Year 3 Monitoring Report

MOCKINGBIRD SITE

NCDMS Project # 100021 (Contract # 7185)

RE: Mockingbird Site: Year 3 Monitoring Report (NCDMS ID 100021)

2023 Mockingbird GW1

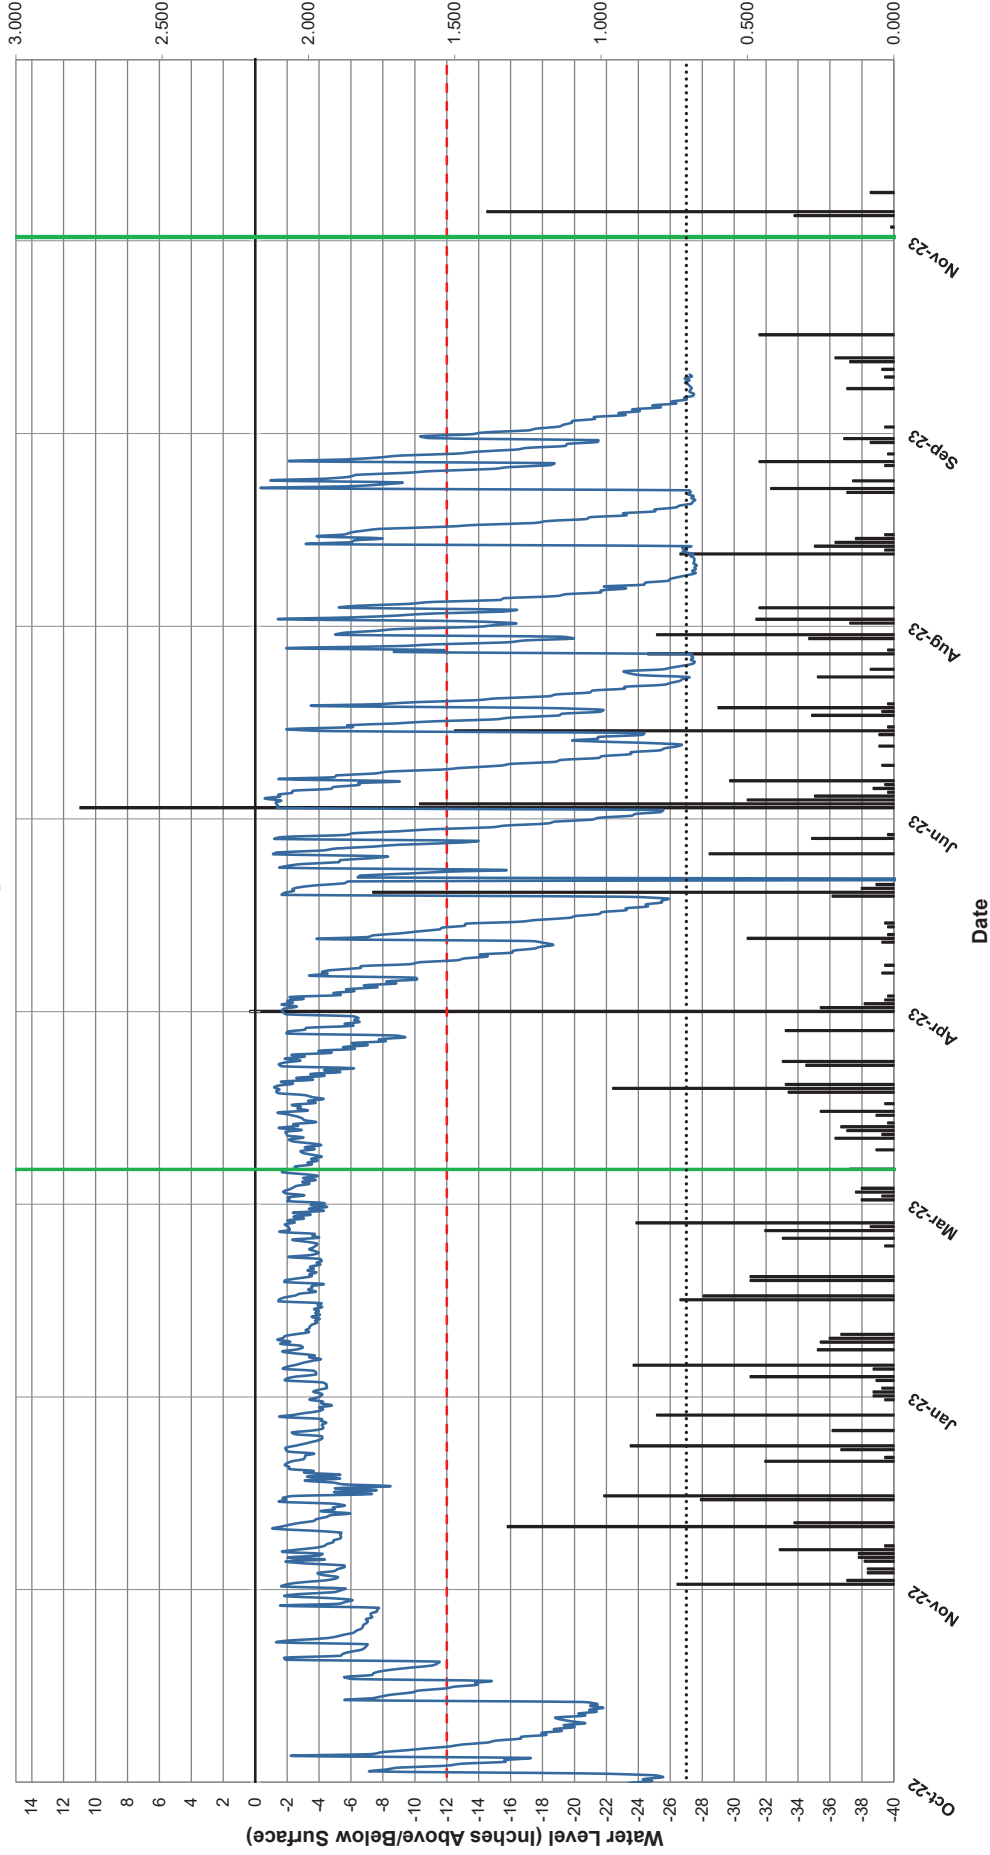
- Thank you for providing the GW gauge data and graph as requested at the 2023 Credit Release meeting.
[Thank you.](#)
